3rd Further Information

Proposed Temporary Open Storage of Construction Materials and Machinery with Ancillary Facilities and Associated Filling of Land and Pond for a Period of 3 Years in "Agriculture" Zone, Lots 1191 (Part), 1194, 1195, 1196, 1197 S.A (Part), 1197 RP (Part), 1198 S.C (Part), 1198 RP (Part), 1205 RP (Part) and 1208 in D.D. 109 and Adjoining Government Land, Kam Tin, Yuen Long, New Territories

(S.16 Planning Application No. A/YL-KTN/1184)

Response-to-Comment (RtC)

FIGURE NUMBER
FIGURE 3-2

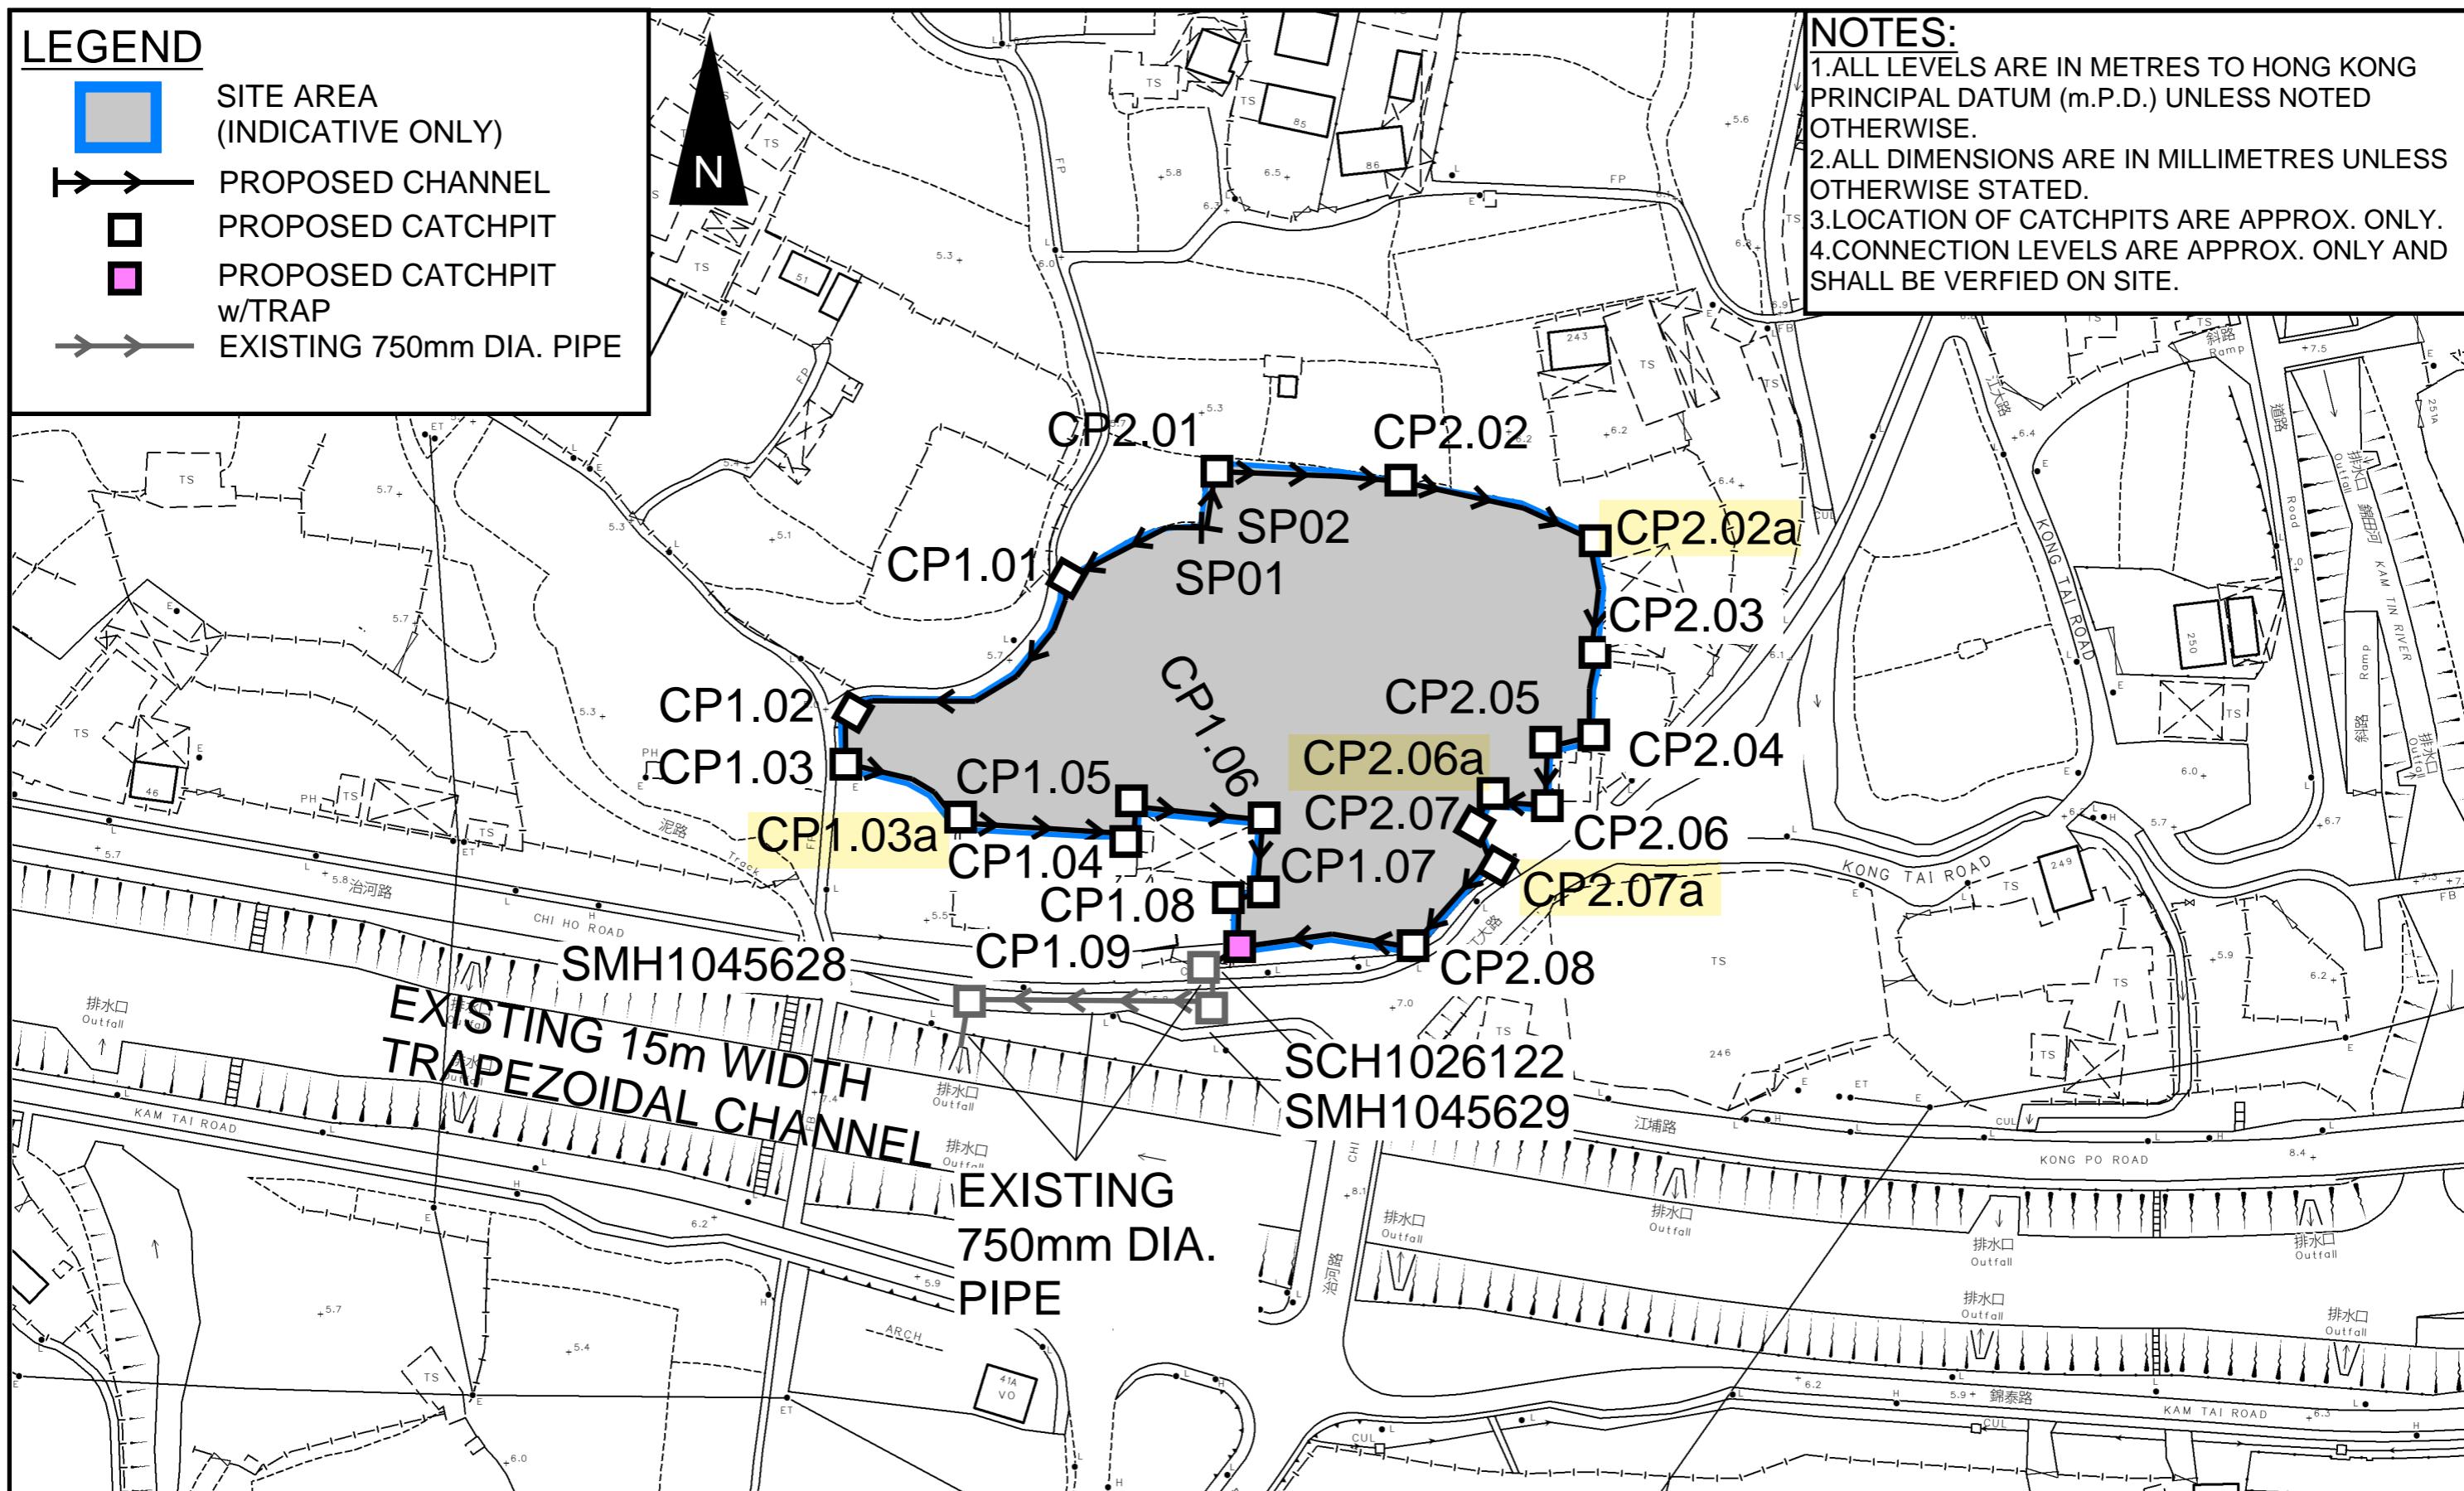
(k)	Catchpit should be provided where a proposed surface channel changes direction.	Noted.
(l)	Figure 3-2: The applicant should clarify type of the proposed drainage facilities i.e. 'E1'. shown in the schedule.	'E1' refer to standard manhole type E1. Standard drawings are enclosed at Appendix C of the revised drainage proposal.

FIGURE NUMBER
FIGURE 4

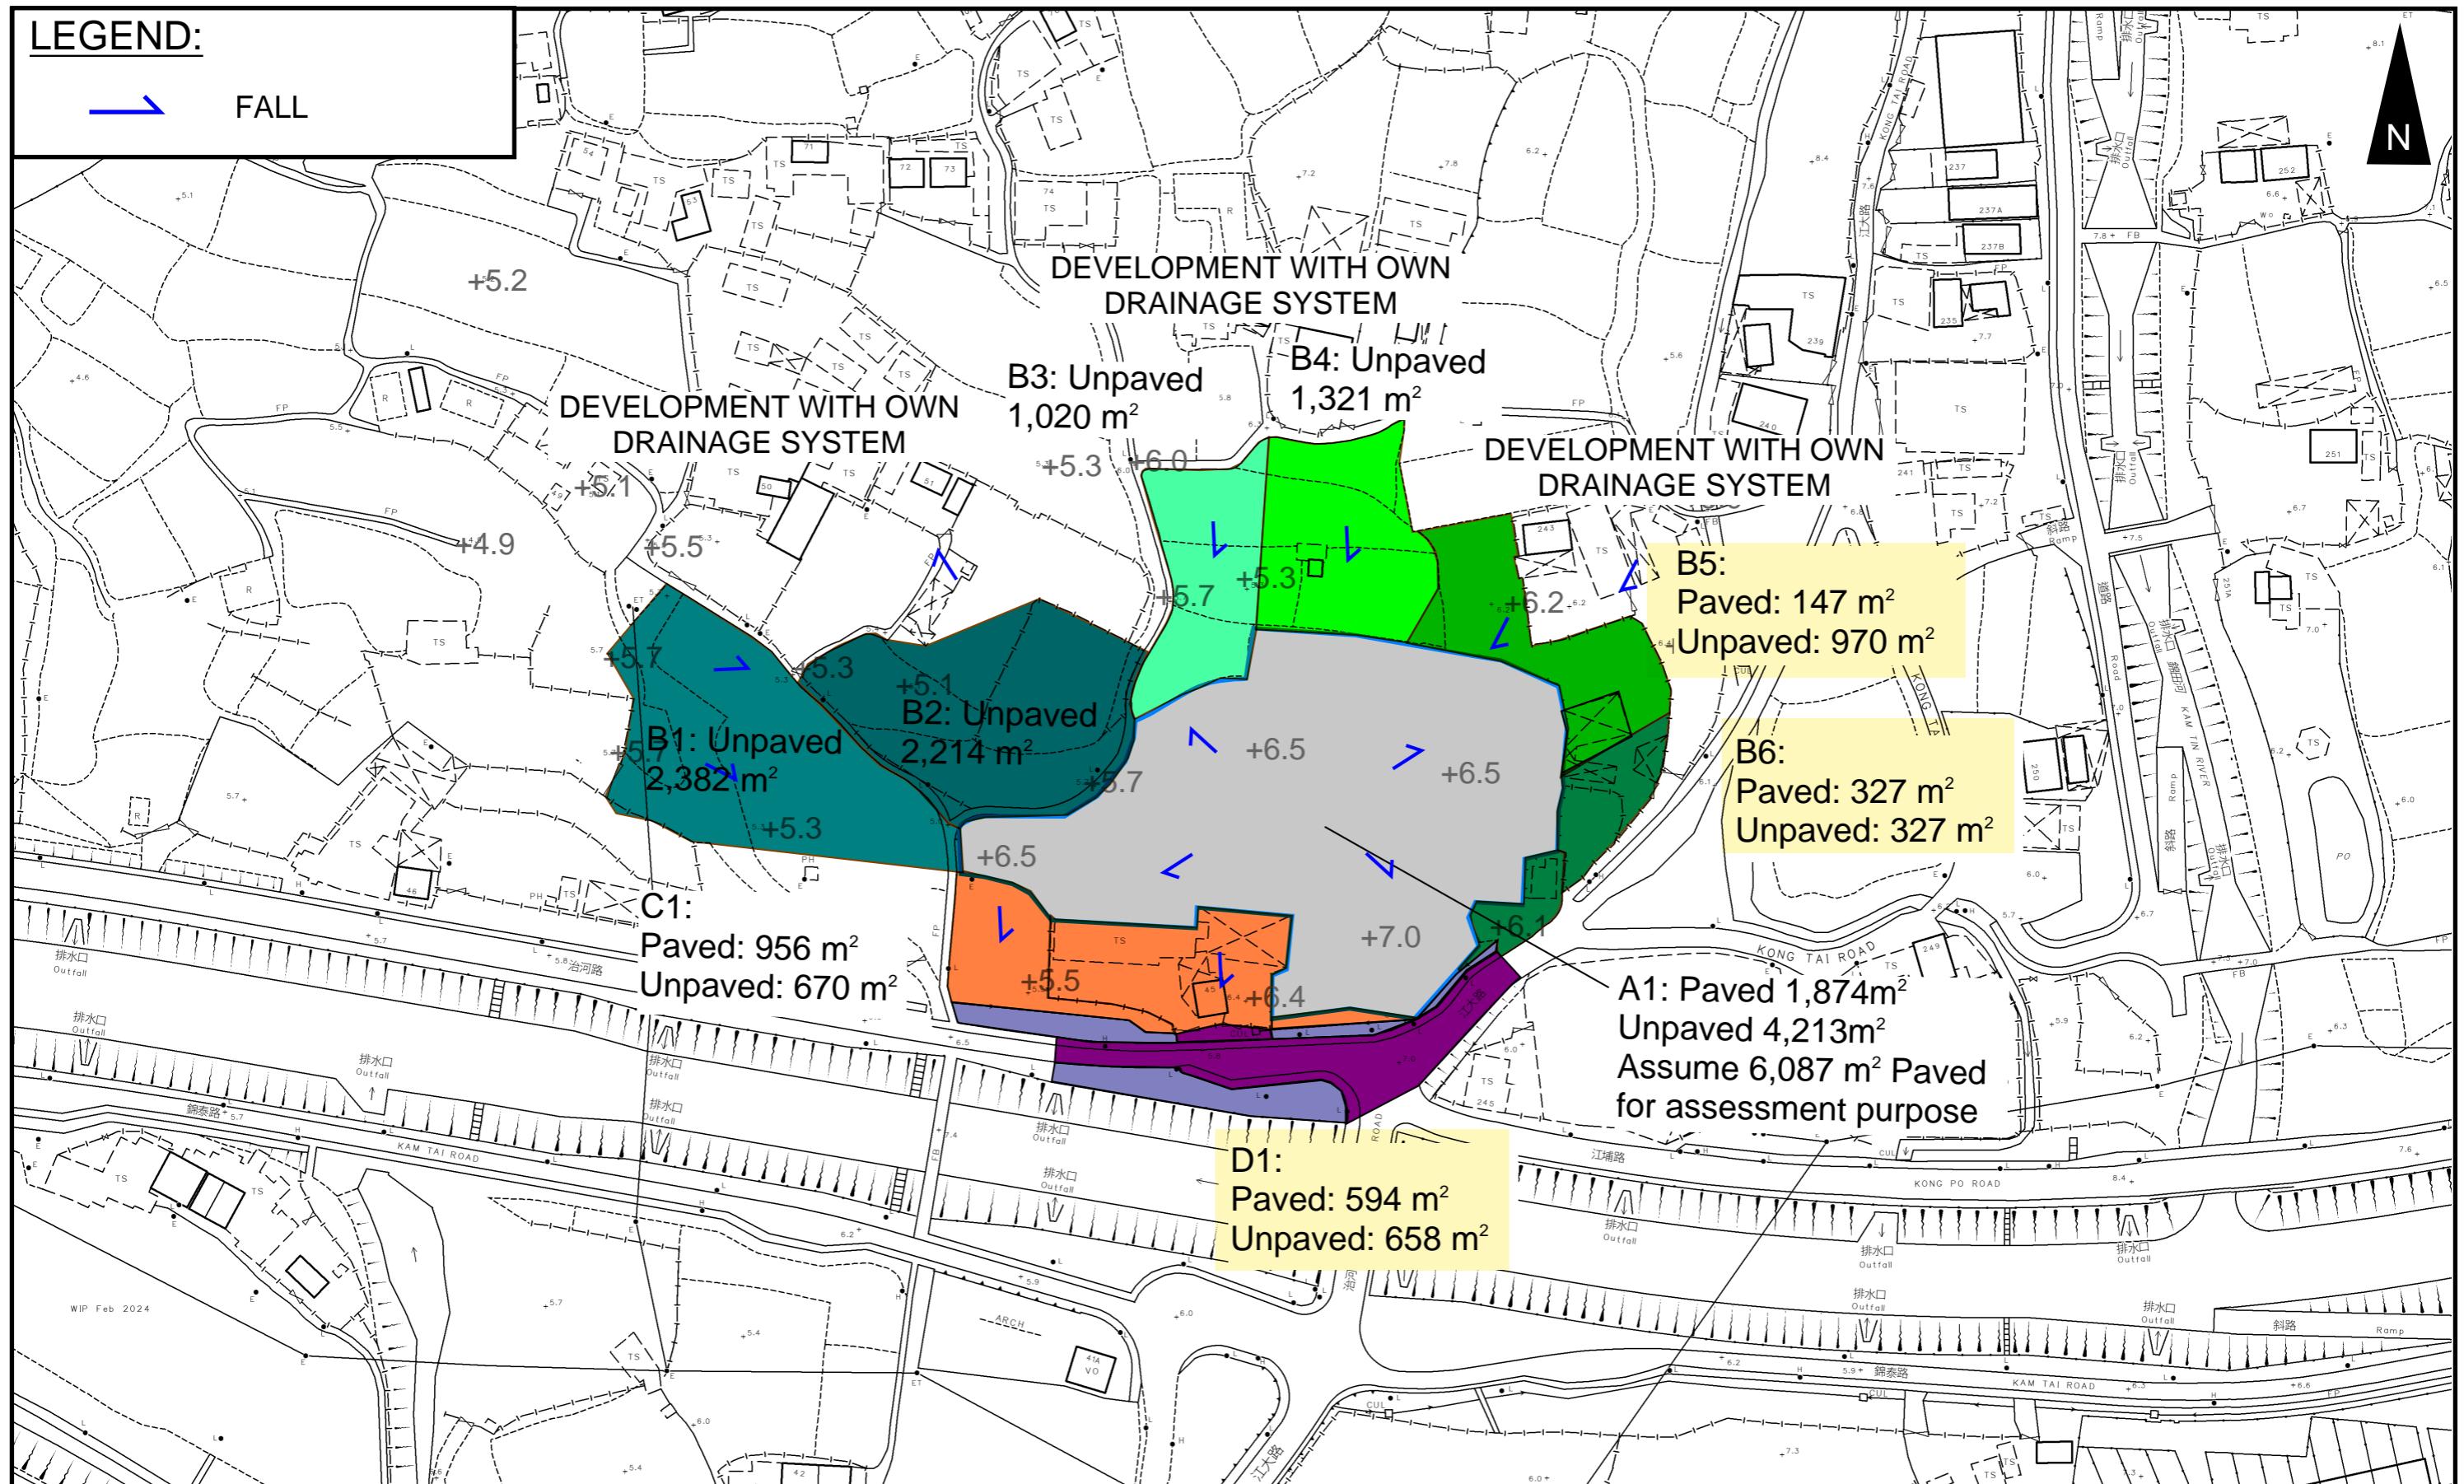
(d)	The proposal should indicate how the runoff (the flow direction) within the site and from the adjacent areas would be discharged to the proposed drainage system.	Please refer to the updated Figure 4 of the revised drainage proposal. For flow direction within the Site, please note the site catchment A1 is considered in calculation of all proposed drain.

(m)	The applicant should review hard paved area and unpaved area shown in the submitted hydraulic calculation. According to the topography, paved area should be more than that shown in the submission.	The catchment plan has been updated.

**FIGURE NUMBER
FIGURE 5**

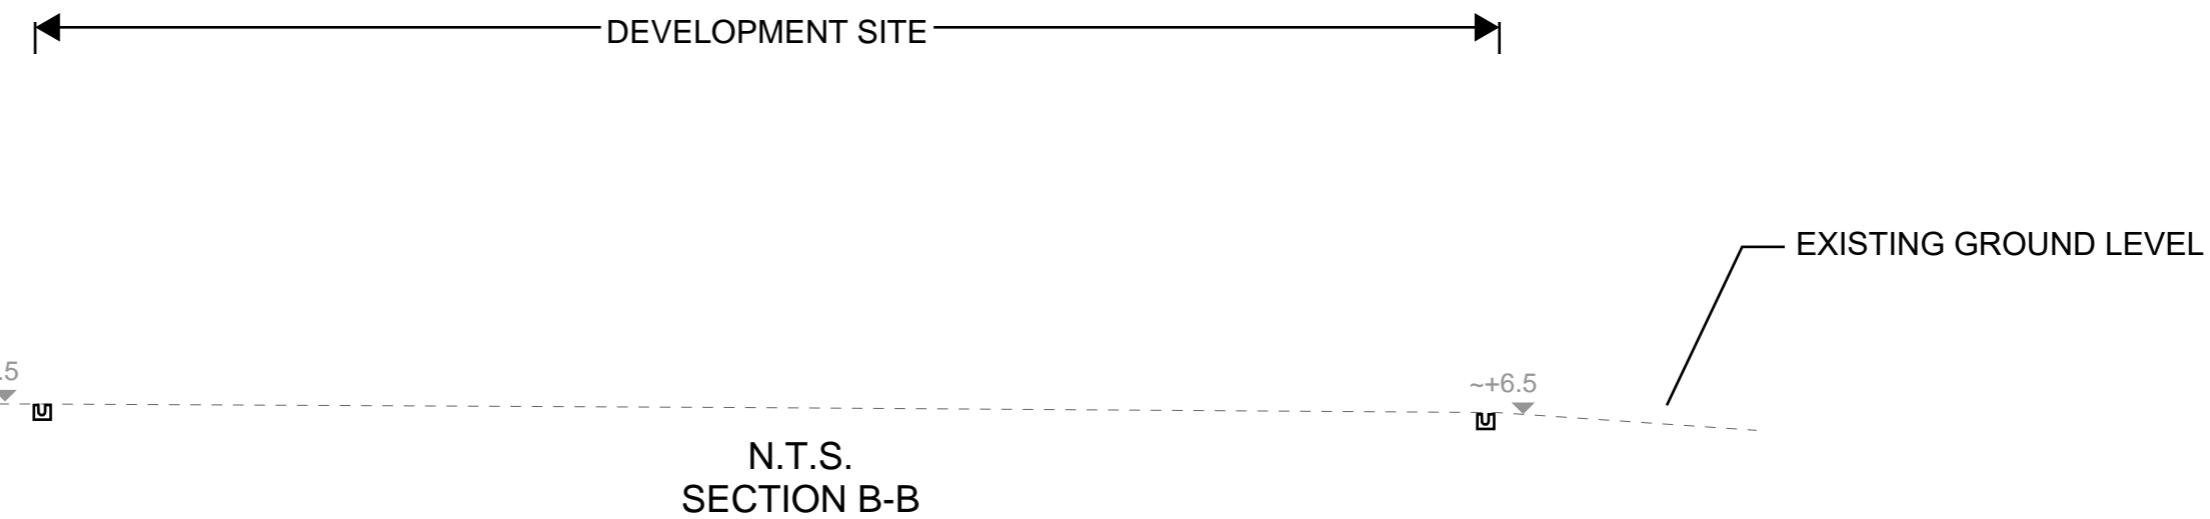
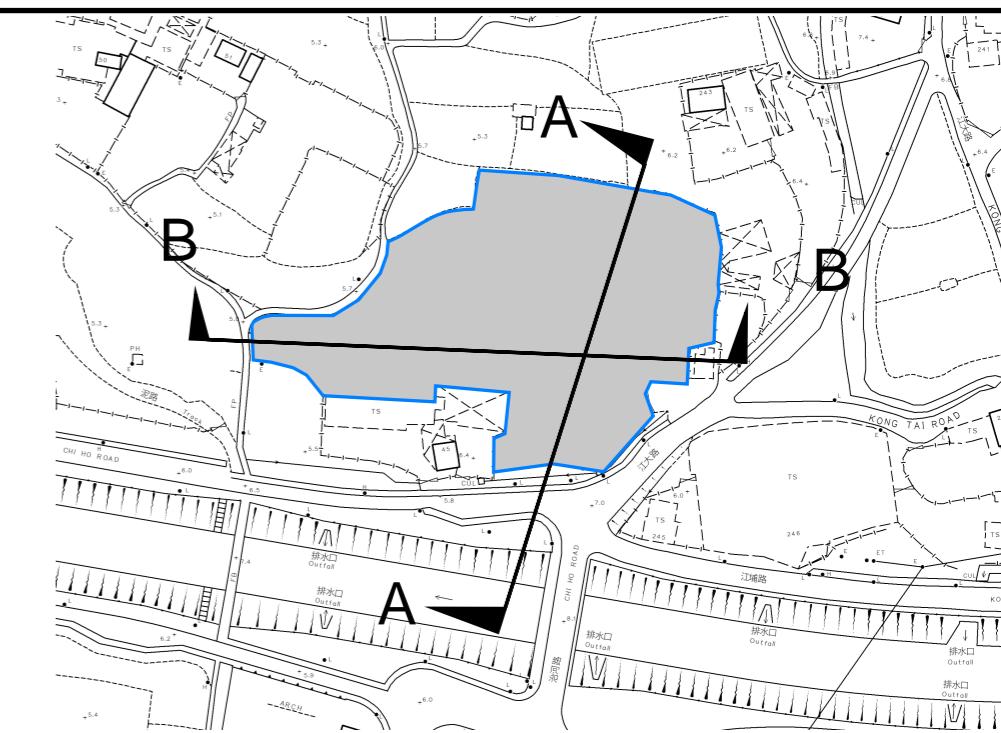
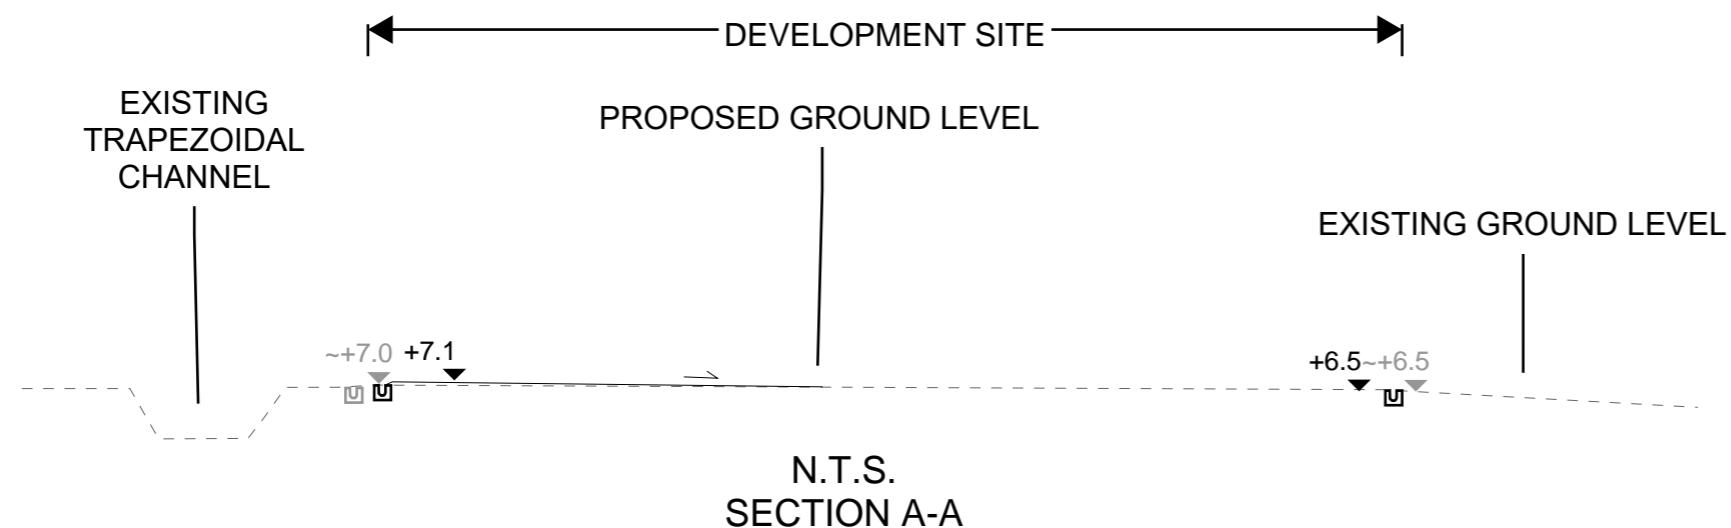
(b)	<p>Cross sections showing the proposed drainage facilities and existing and proposed ground levels of the captioned site with respect to the adjacent areas should be given.</p> <p>Please note that the existing level is proposed to be maintained and not more than 200 mm concrete in thickness will be used for the formation of circulation space and open storage space when required.</p> <p>The cross sections are shown in Figure 5 of the revised drainage proposal, which is enclosed at Annex 2.</p>
